DOE/EIS-126-F

Final Environmental Impact Statement

**REMEDIAL ACTIONS AT THE FORMER
CLIMAX URANIUM COMPANY
URANIUM MILL SITE
GRAND JUNCTION, MESA COUNTY,
COLORADO**

VOLUME I - TEXT

FIGURE 3.1
FINAL CONDITION - STABILIZATION ON SITE

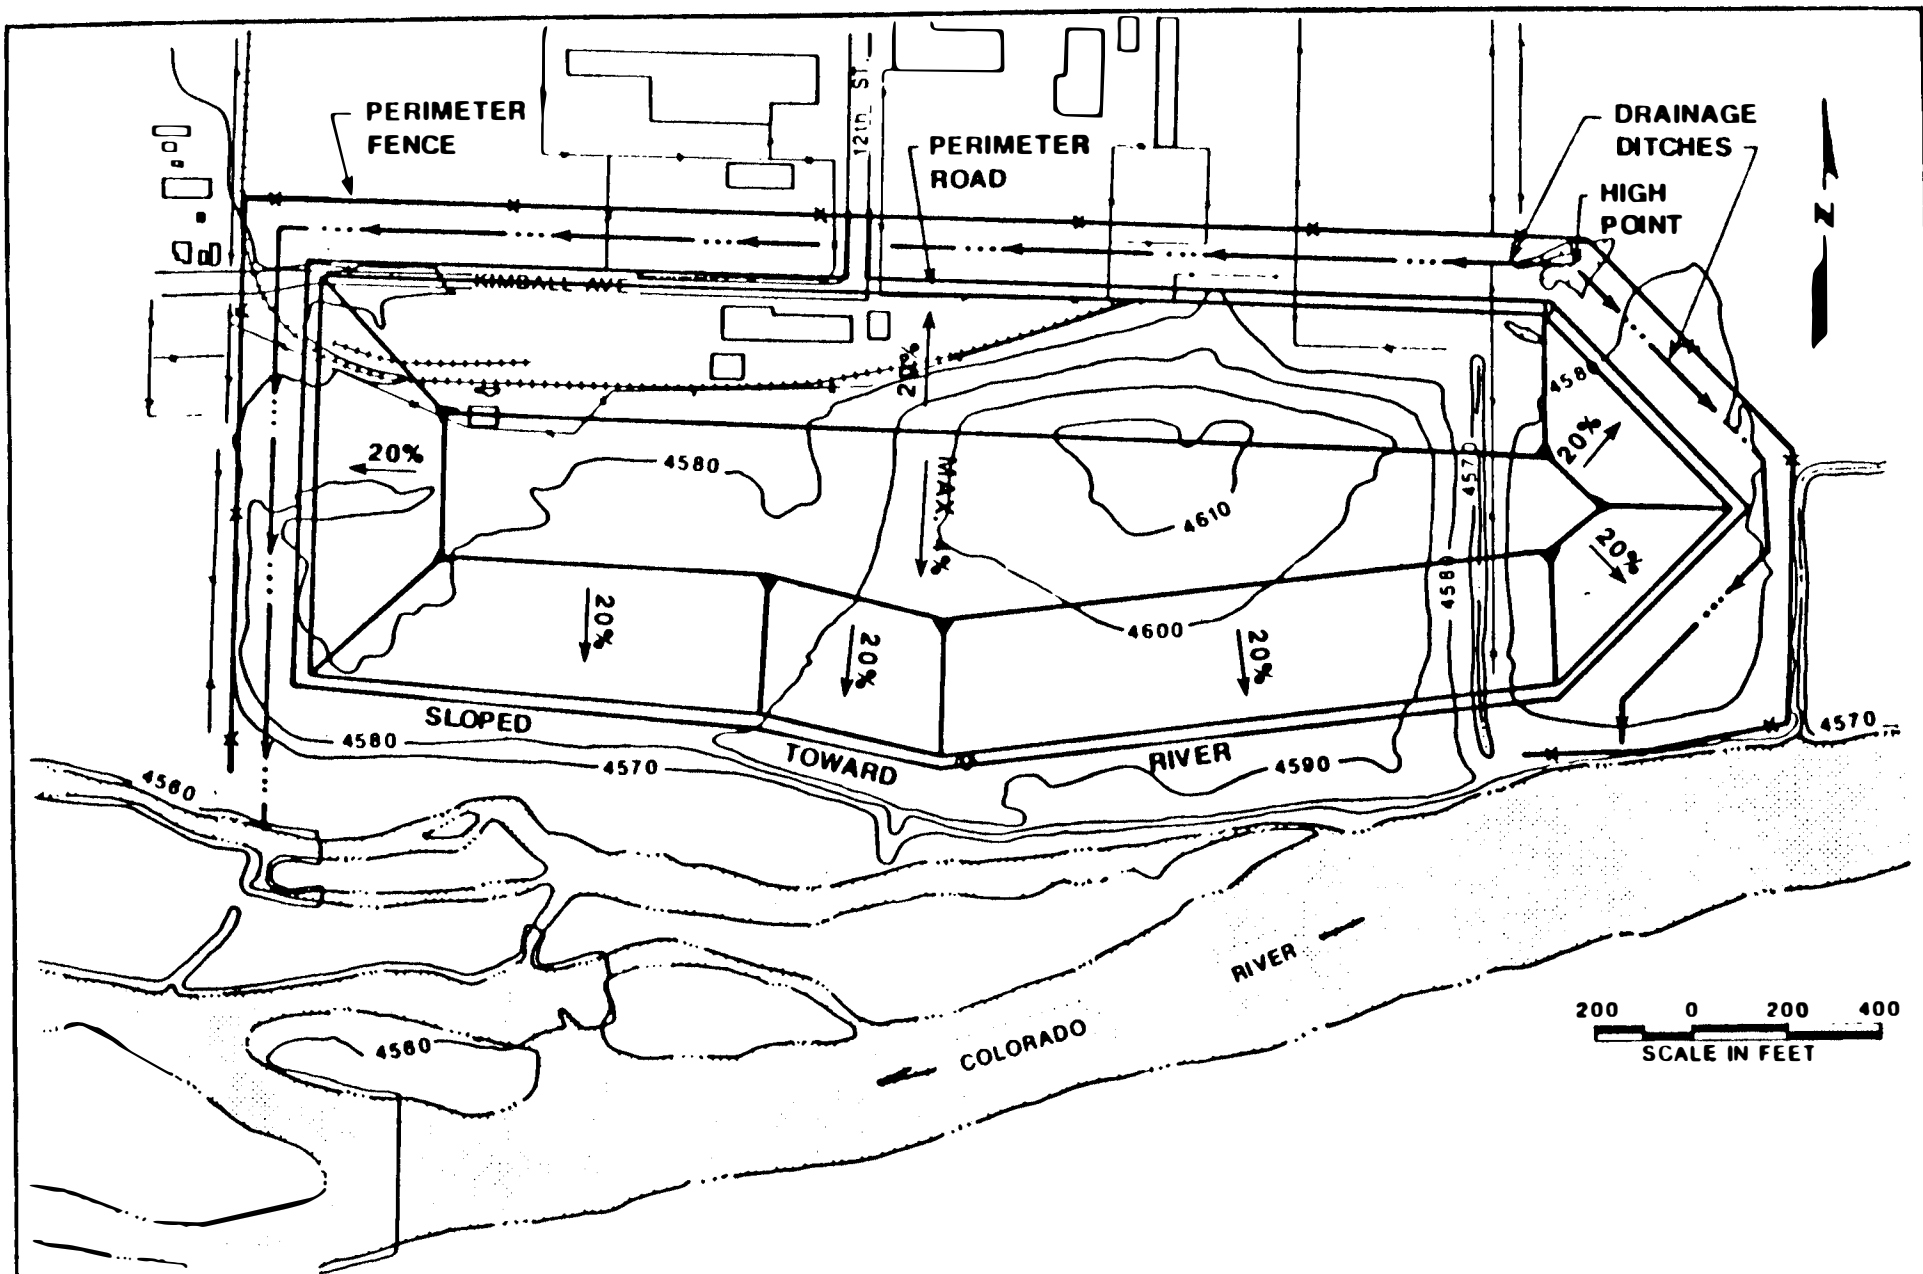
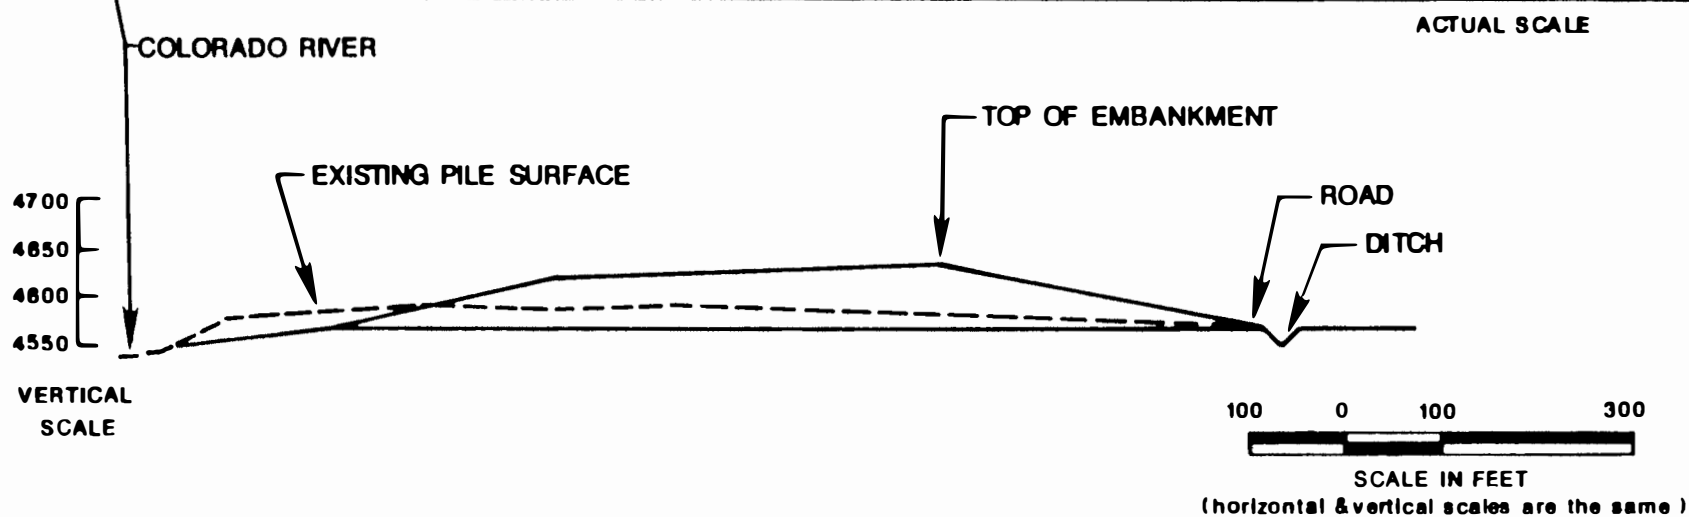
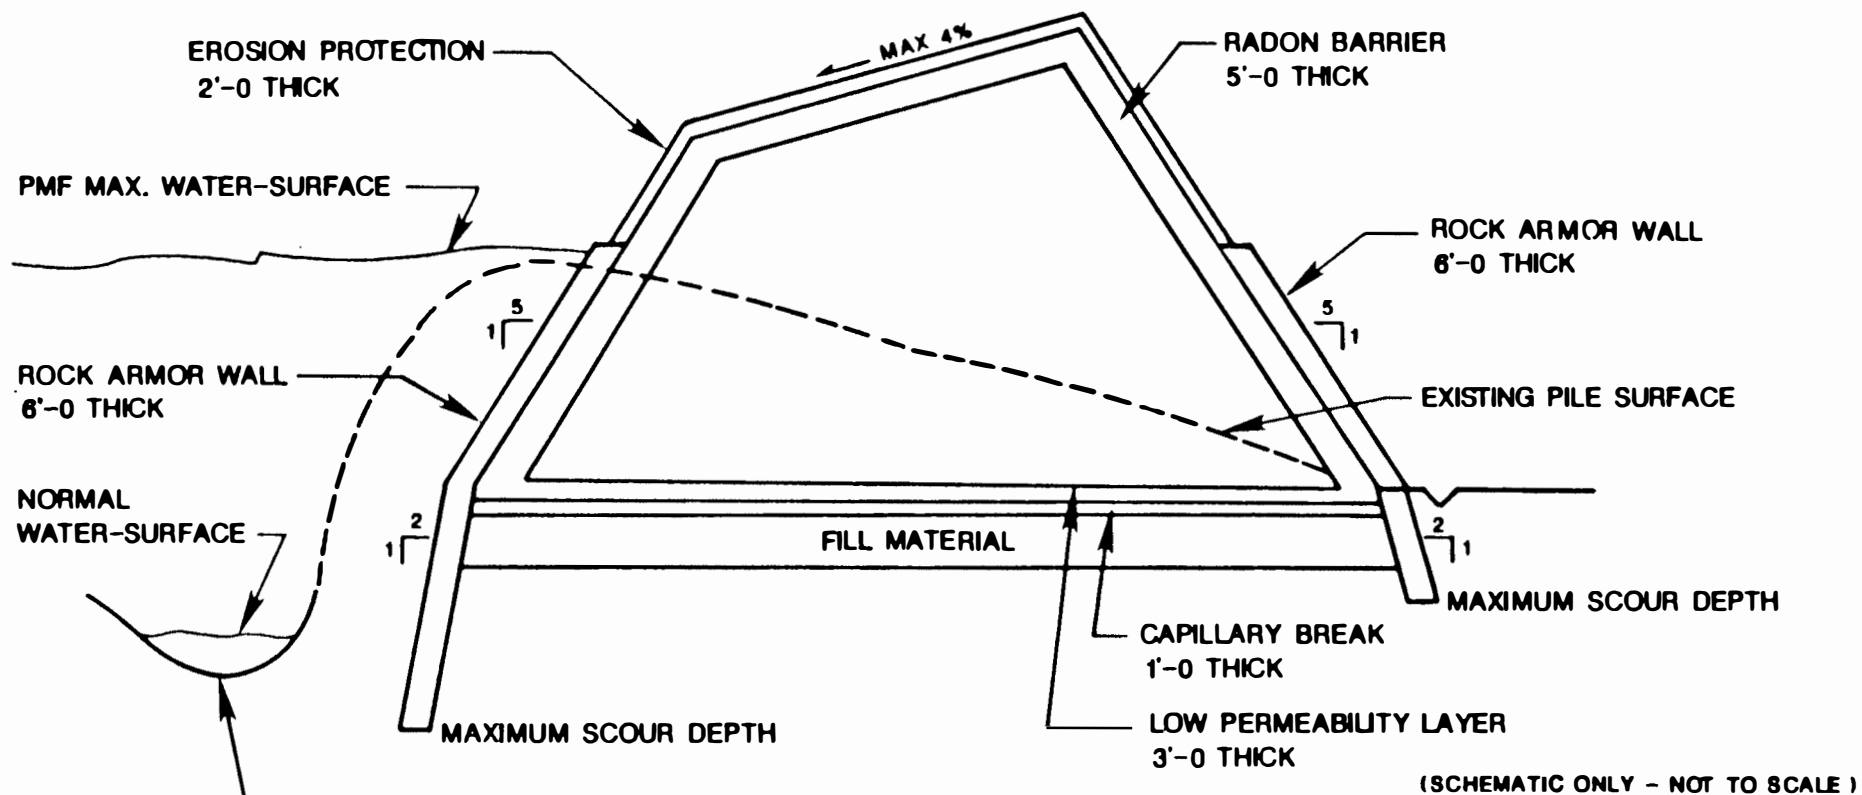
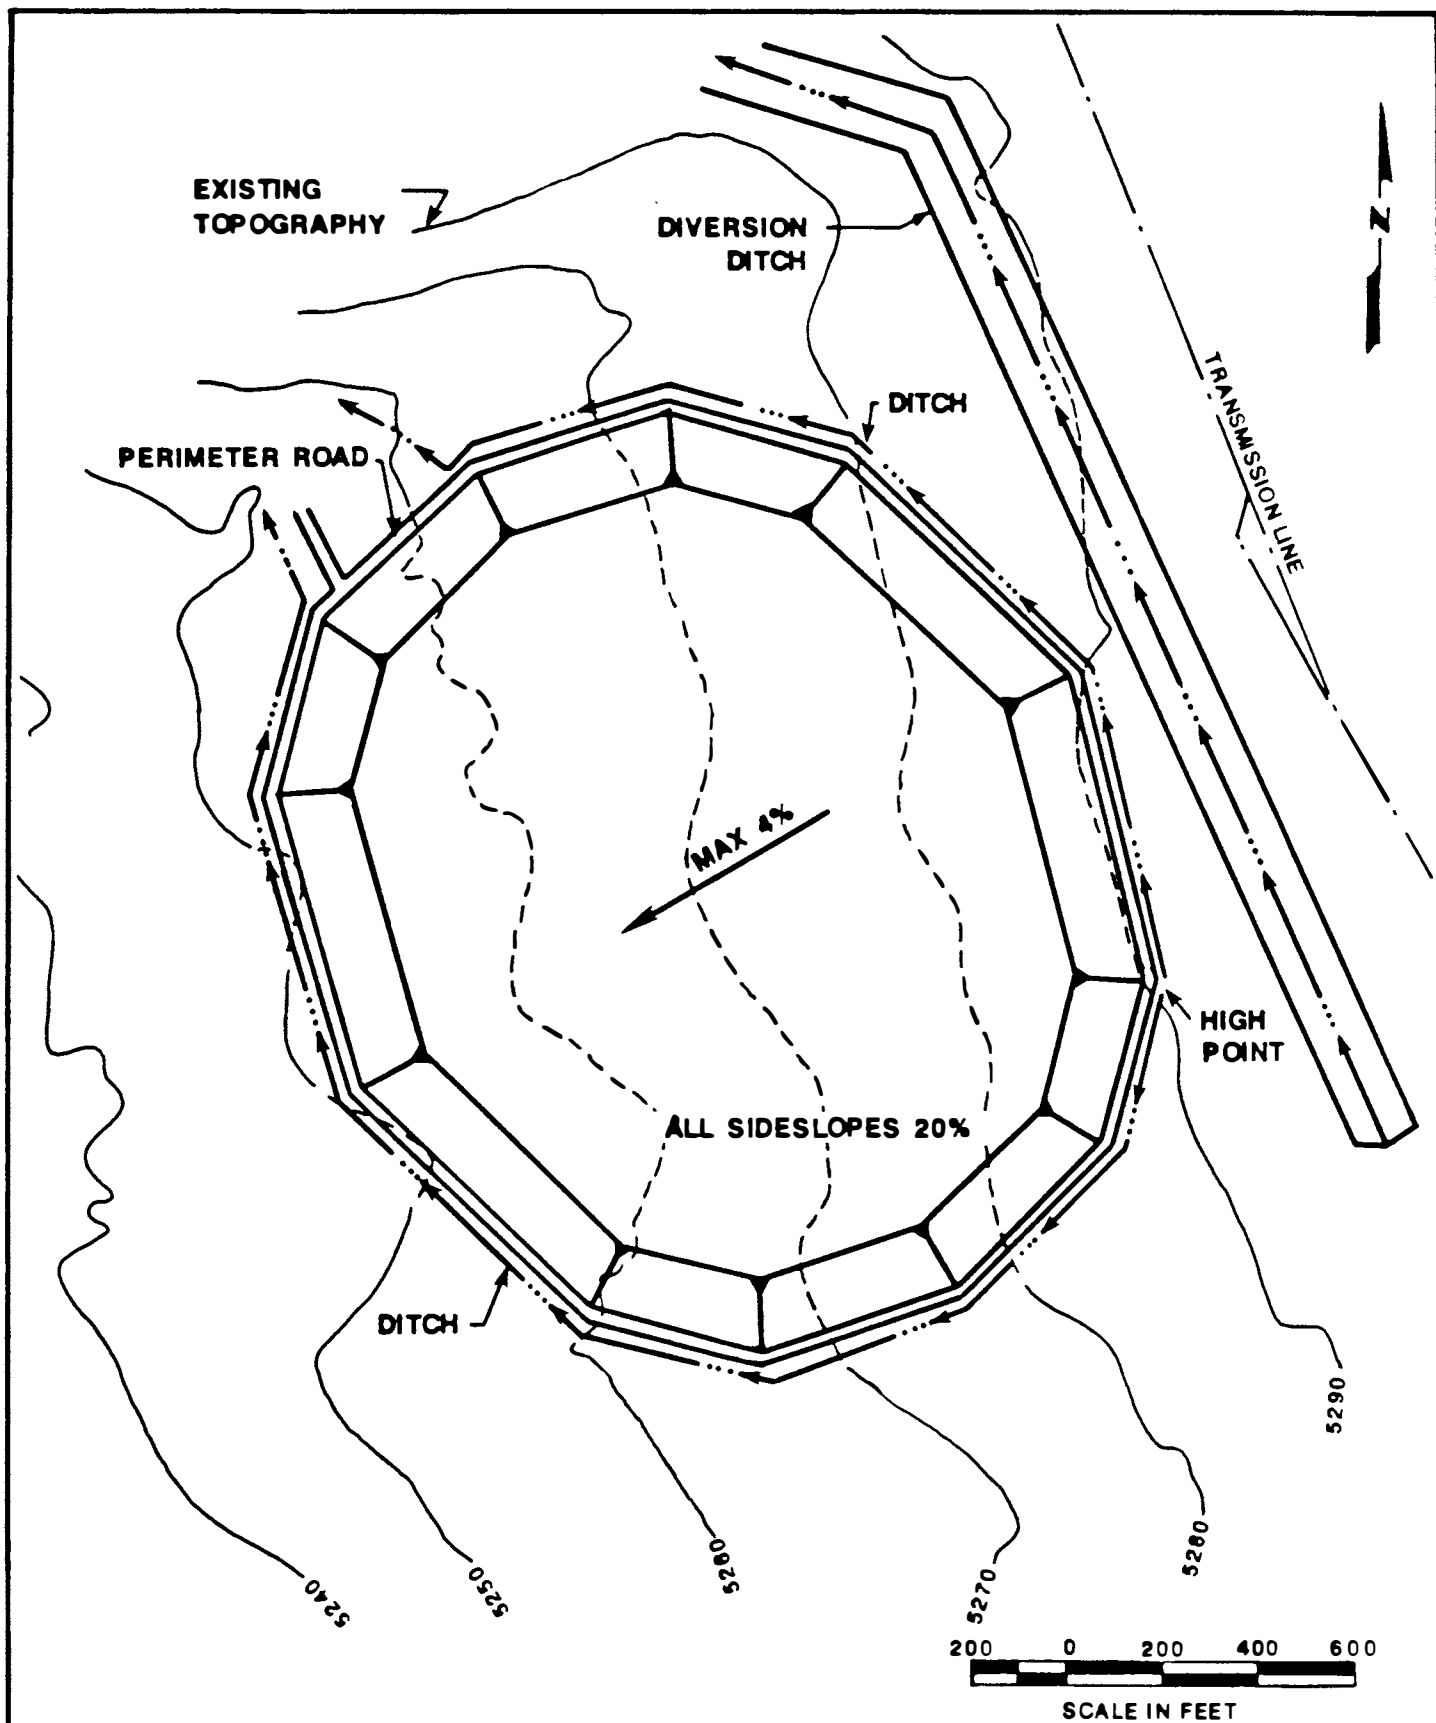
Since both the parent and relocation sites will be with us for centuries, the visual impact of the end result must be completely addressed and optimized. Unfortunately, your proposals (DEIS, Vol. 1, Fig. 3.1, 3.2, 3.3) are ugly and unimaginative - efficient but unaesthetic. When humans view these sites (and who can foresee how populations and their viewing angles will change over the decades) they must not be confronted with the tomblike monumental structures you propose - foreboding and depressing monstrosities guaranteed to shrink the soul. This would be a tragic and shortsighted result for such an enormous undertaking.

FIGURE 3.4
TYPICAL CROSS-SECTION - CHENEY RESERVOIR ALTERNATE DISPOSAL SITE

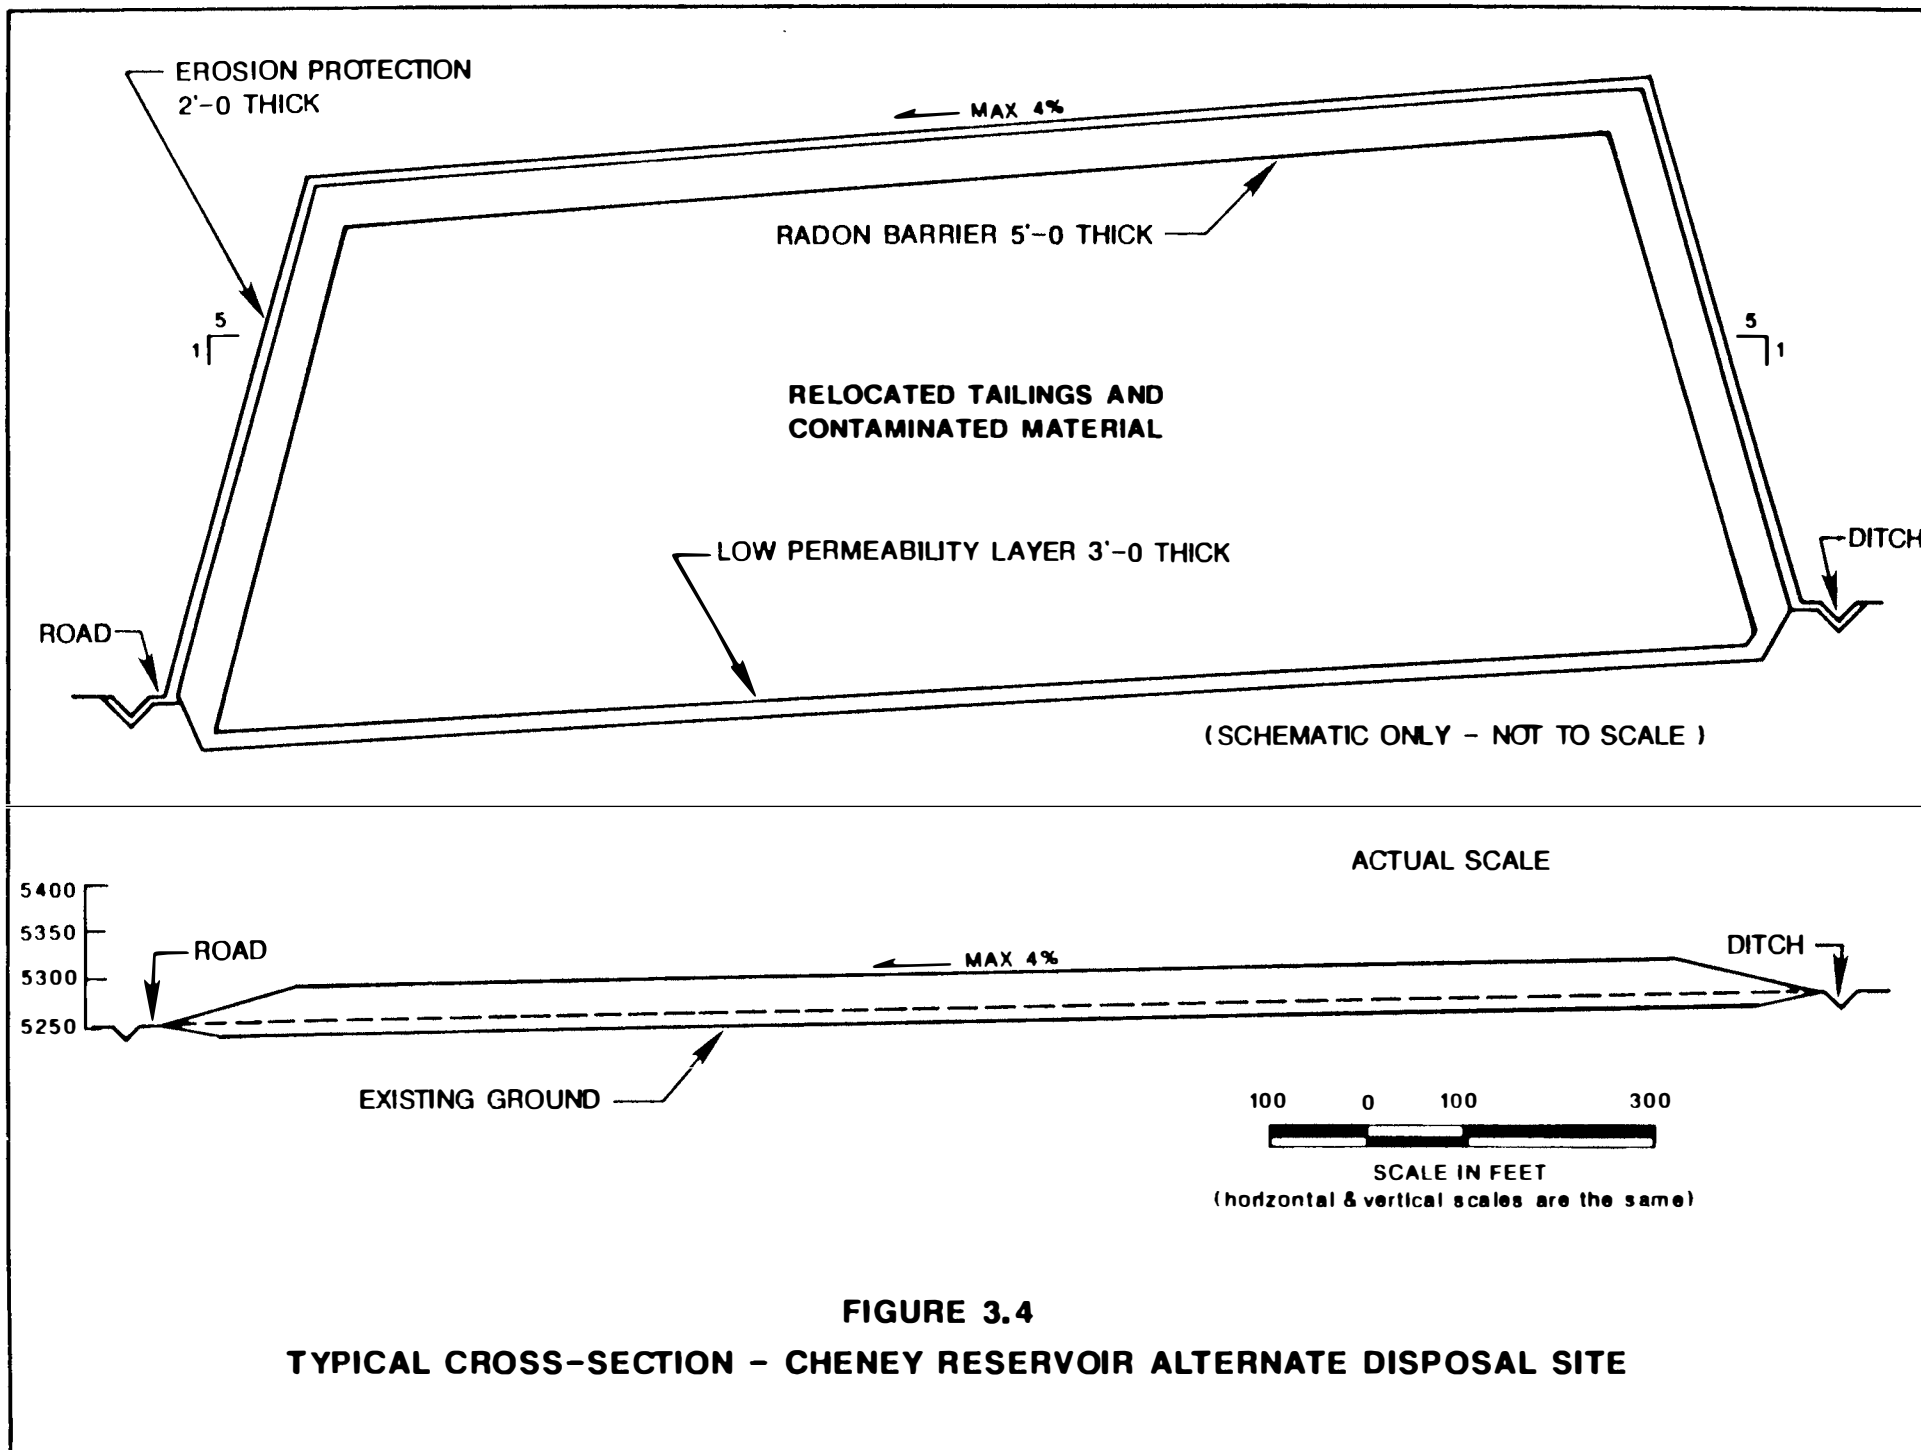
Comment #	Page	Paragraph	Comment
29	35	Figure 3.4 6.4.25	Two feet of rock on top of 5'0" of compacted soil cover does not appear to offer sufficient protection of the radon barrier and the tailings (i.e. provide for long-term stability). See comment #28.
30	38	6.4.22	8th bullet - See comment #26.
31	39	6.4.24	See comment #27.
32	42	Figure 3.6 6.4.25	See comment #29.
33	46	6.21.3	1st sentence - See comment #2.
34	46	6.21.4	The 800+ private removals by property owners since 1972 should be noted. See comment #3.
35	47	8 6.21.6	Final condition - Nothing is noted about deposits now under structures that are not being removed, but could pose a problem if the existing structure was torn down and a new tighter structure was constructed over the old deposit. This type of deposit, and others not discussed in the DEIS indicate that the last statement made in this paragraph is invalid and should therefore be omitted. See comment #86.
